RECEIPT DATE: 6-24-14 **ONSITE SEWAGE DISPOSAL SYSTEM**

PROPERTY ADDRESS: 15275 Sweetbay Street

SITE PLAN FOR BAT INSTALLATION

From: Williams, Jeffrey
Sent: Thursday, April 10, 2014 12:09 PM
To: 'cwillett@khov.com'; Brian Collins
Subject: Belle Haven lots 15 and 26

BELLE HAVEN ESTATES
LOT 26
SITE PLAN FOR
BAT INSTALLATION

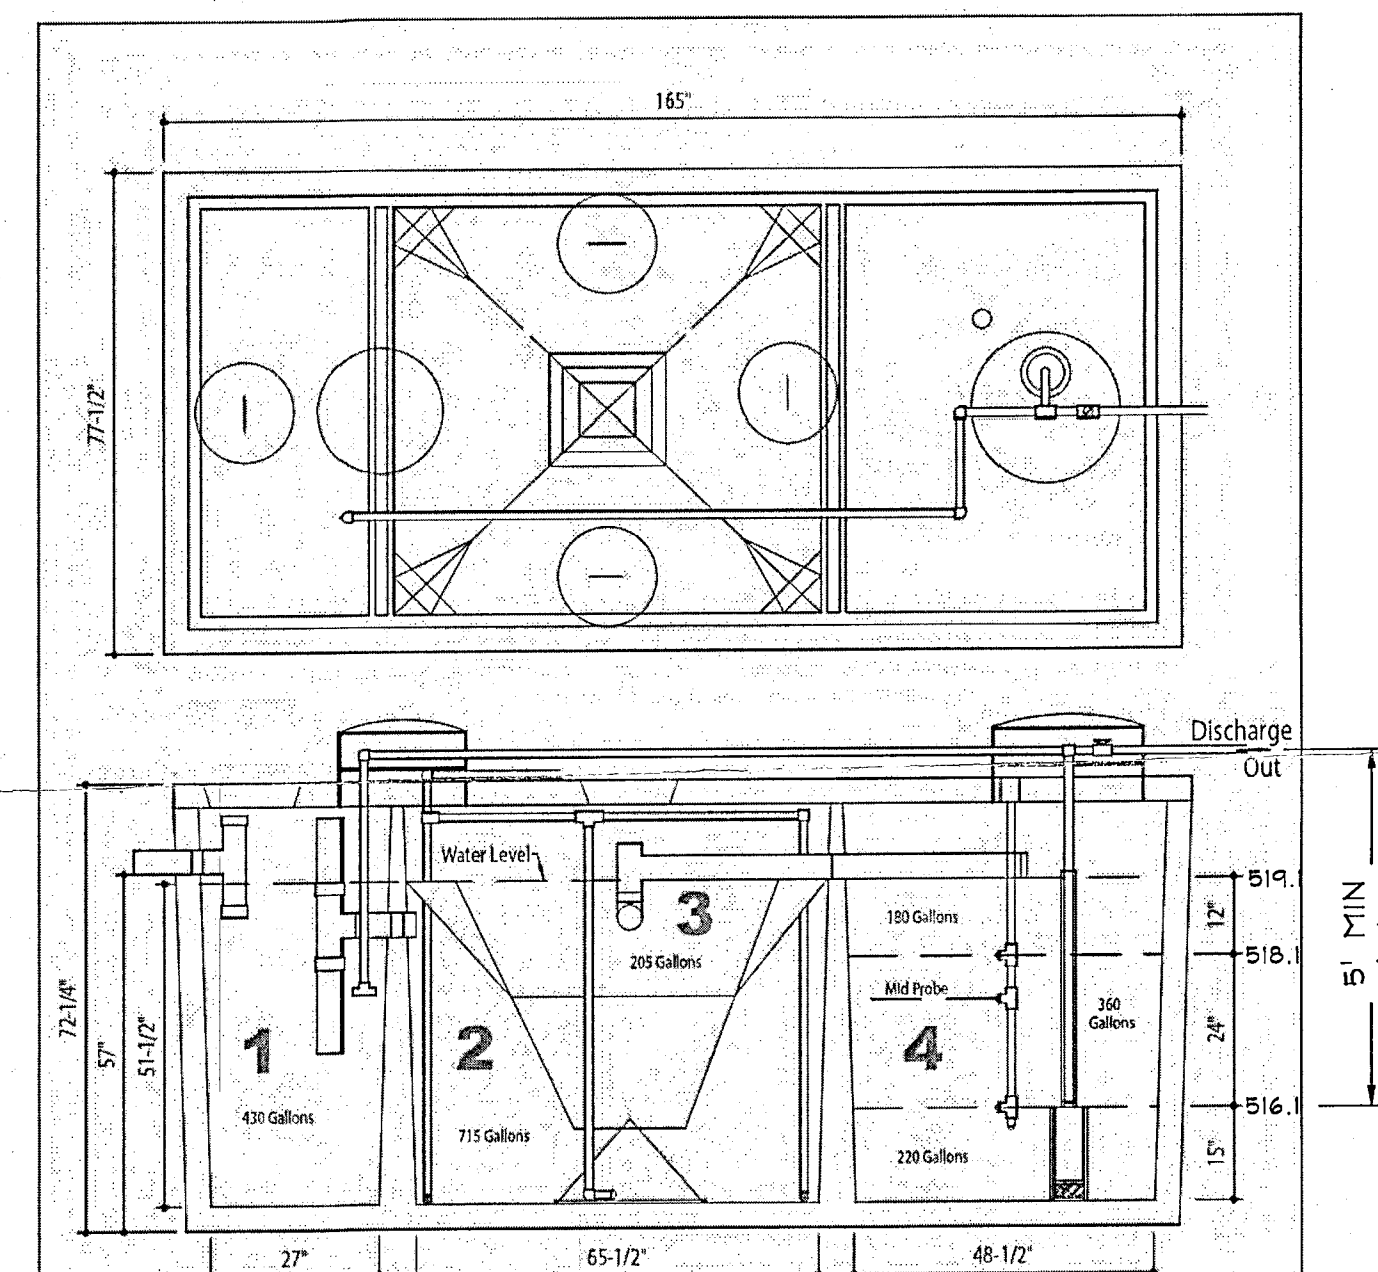
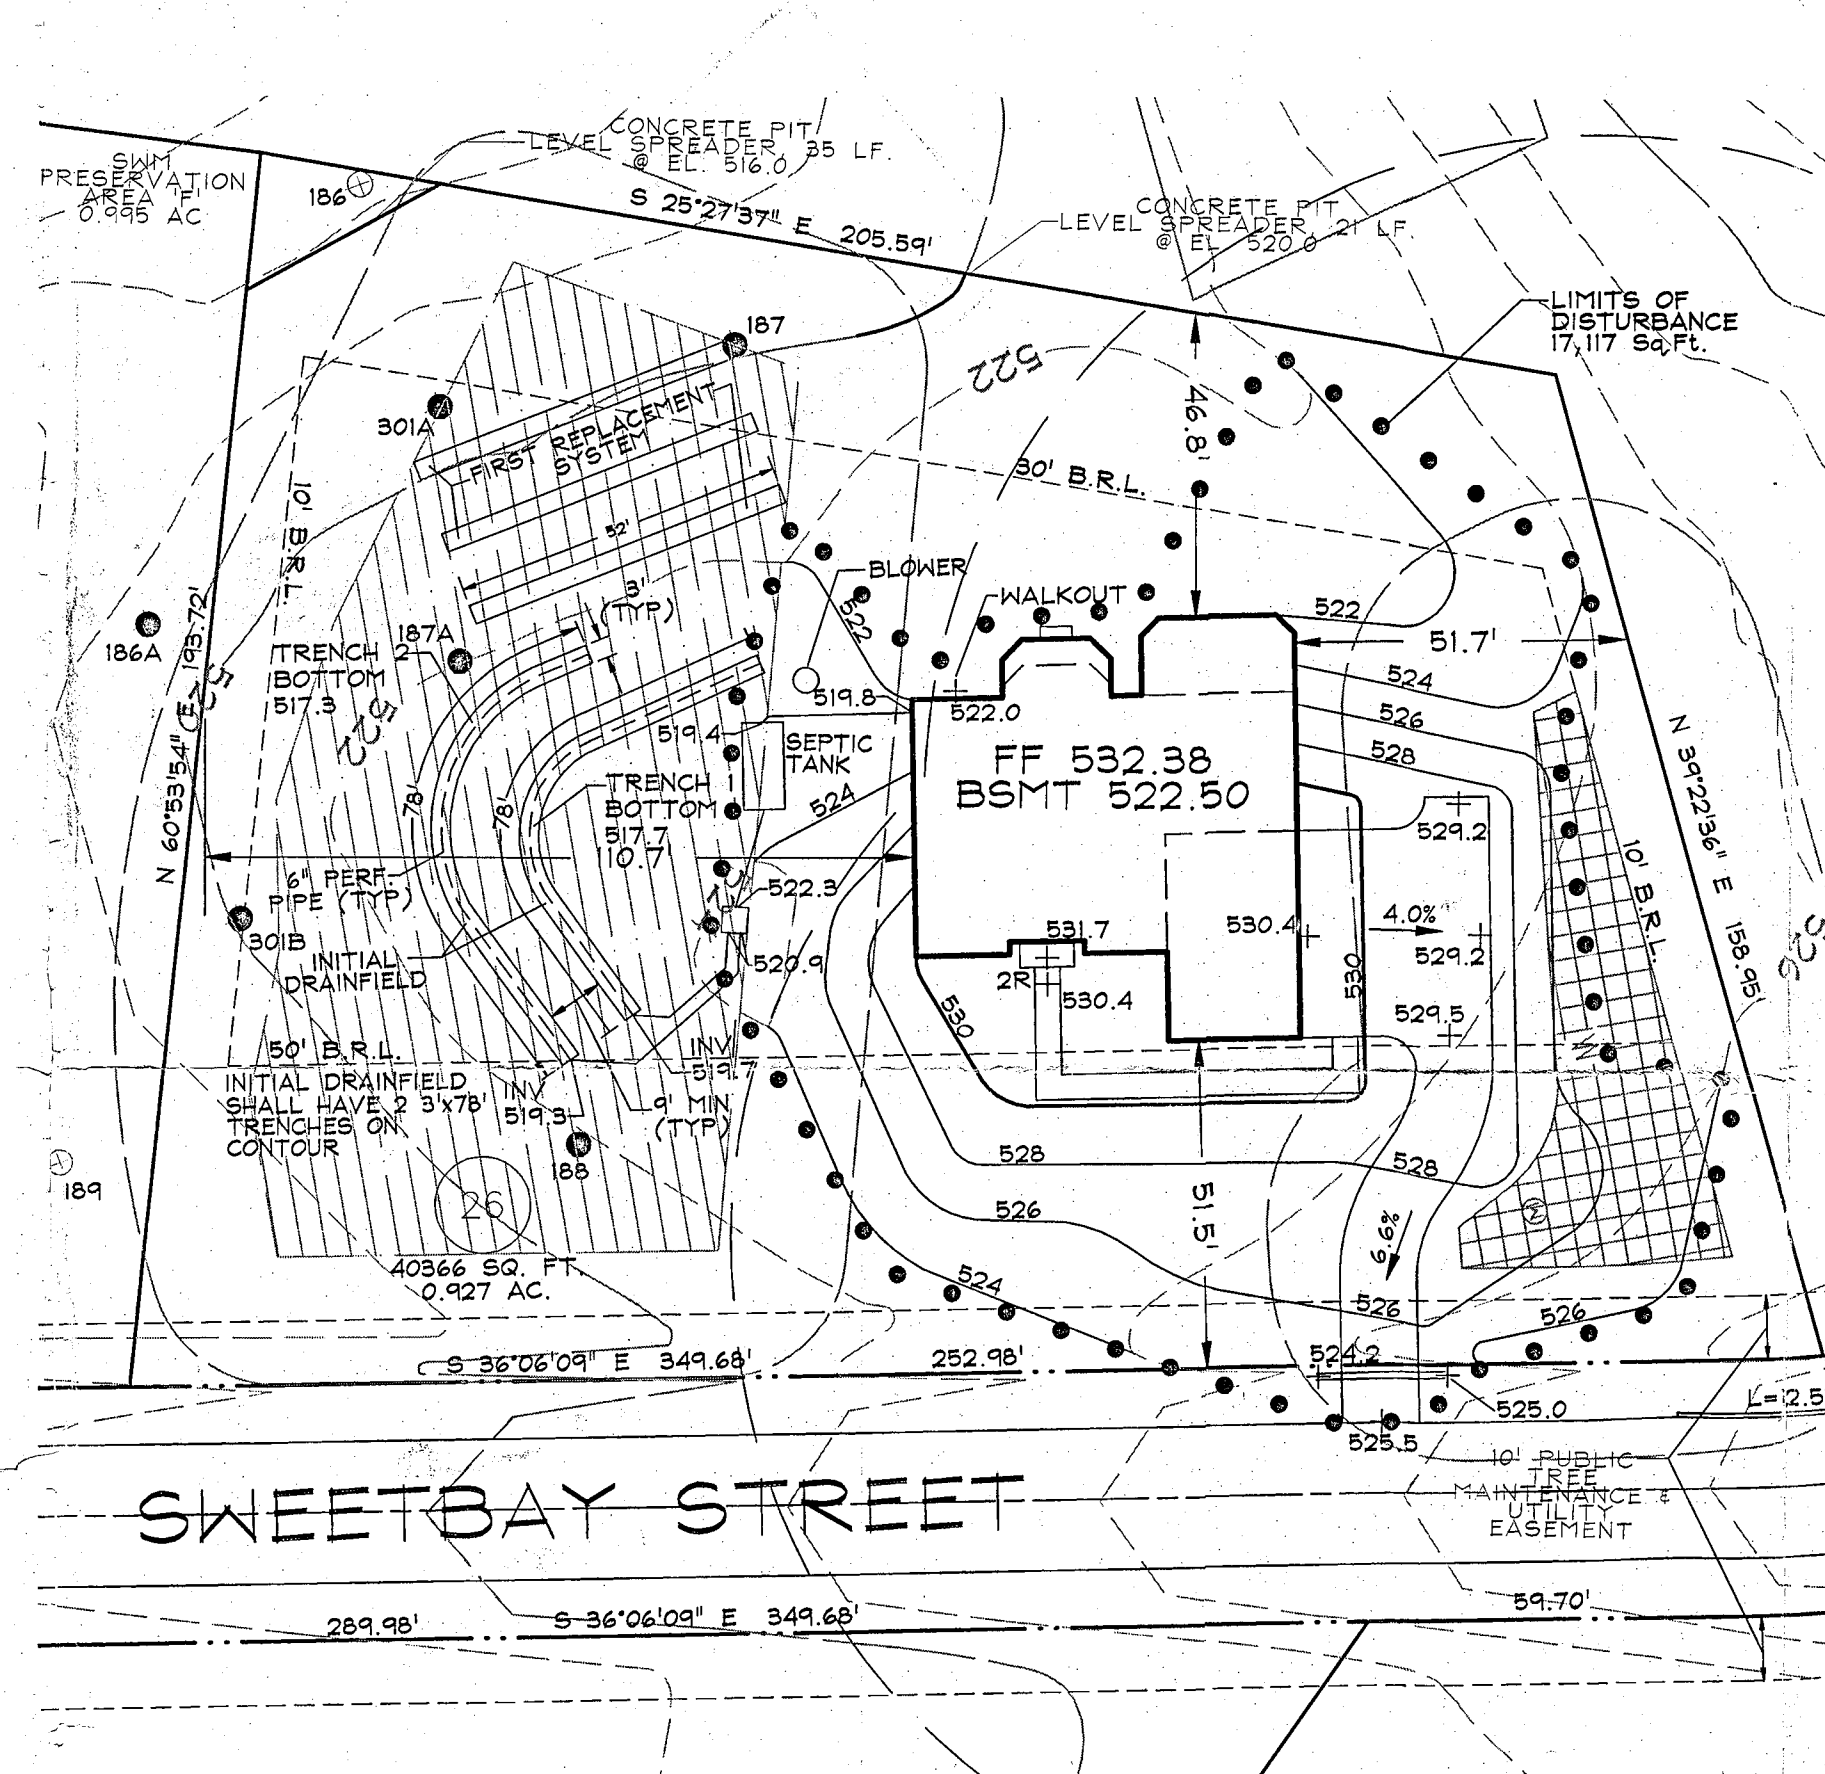
I have reviewed the BAT plans and floor plans for the above referenced lots. Both floor plans indicate 4 bedrooms on the 2nd floor. Both have a full bath in the basement, which along with the door and window in the den make that room a bedroom. Both show a first floor in which it is unclear whether the full bath option was chosen on that floor. If so, the home office becomes a bedroom.

Both BAT plans look good except they are designed for 4 bedrooms. We could keep the floorplans as-is and the BAT plans could be redesigned for 6 bedrooms, or one or both of the rooms could be altered to meet the bedroom exemption in our code. If both are altered to get down to 4 bedrooms, the BAT plans are approvable. If one is altered, the BAT plans would need to be revised for 5 bedrooms.

BAT plan needs
~~details~~ for 5 or 6 bd

If the floorplans are altered, a formal revision to the permit would need to be submitted to DILP with copies of the revision on office or letter size paper for them to scan into Acella and send to the Health Dept.

SECOND FLOOR PLAN
W/ OPT. BEDROOM #5
W/ 4' FAMILY ROOM EXT.

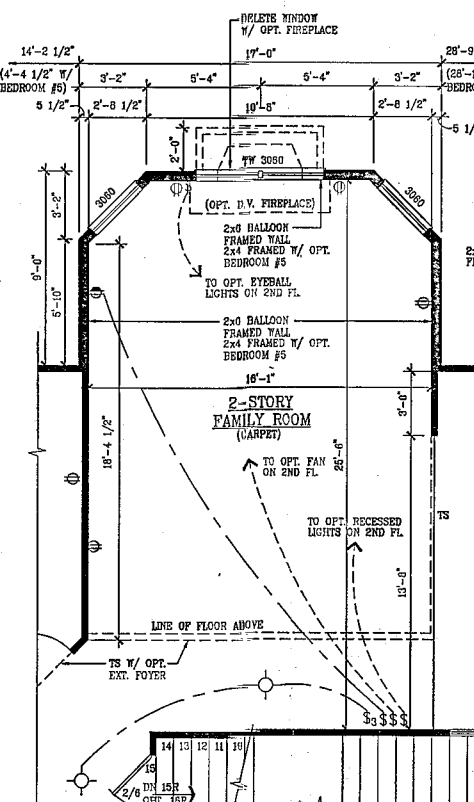
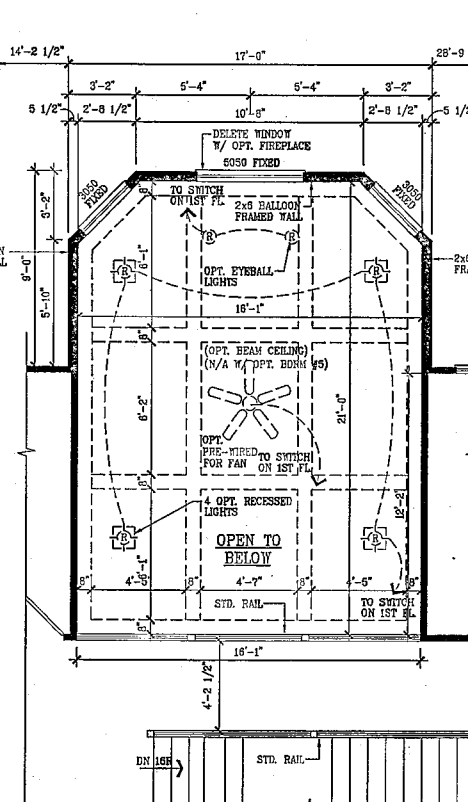
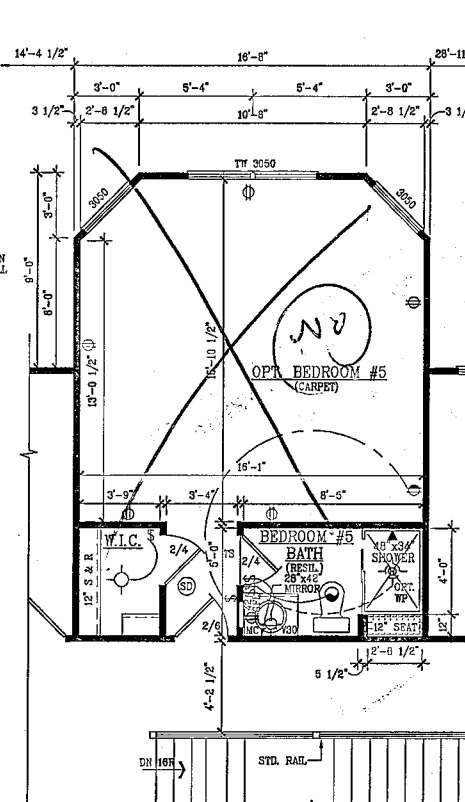
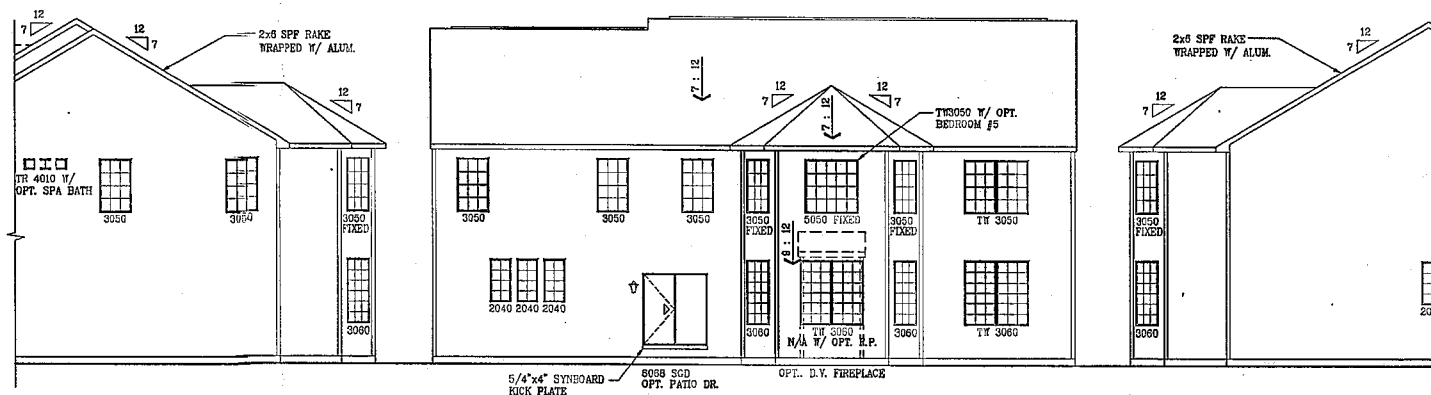
Full bath on 1st fl?
